# Outside Door Weatherstrip - Multiple Concerns

YEAR(S)	MODEL(S)	ADDITIONAL INFORMATION
2013 – 2014	FR-S

### REVISION NOTICE

**Figure 1.**

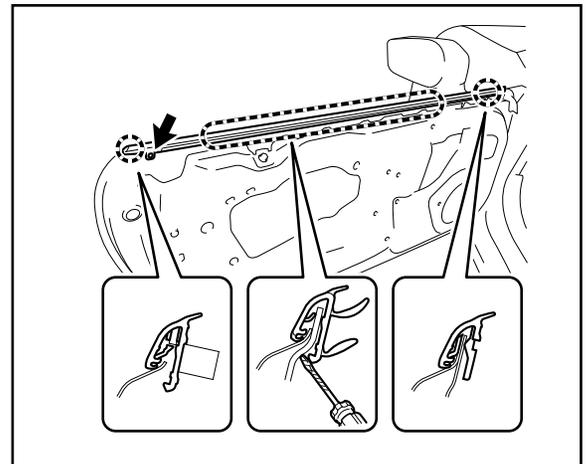
6. Remove front door glass Outer Weatherstrip assembly.
  - A. Remove the screw.
  - B. If necessary, use a screwdriver to disengage the claw and remove the front door glass Outer Weatherstrip assembly.

**Tape the screwdriver tip before use.**

Figure 2.

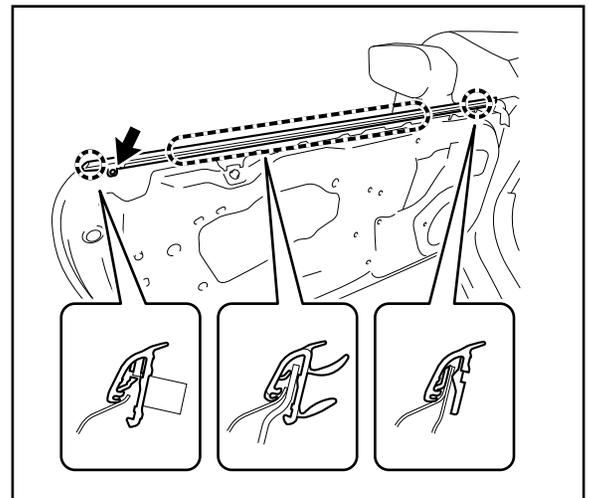
Engage the claws to install the screw and a NEW front door glass Outer Weatherstrip assembly as shown.

Ensure proper installation of Outer Weatherstrip by confirming that the claw attached to the weatherstrip is fully engaged.
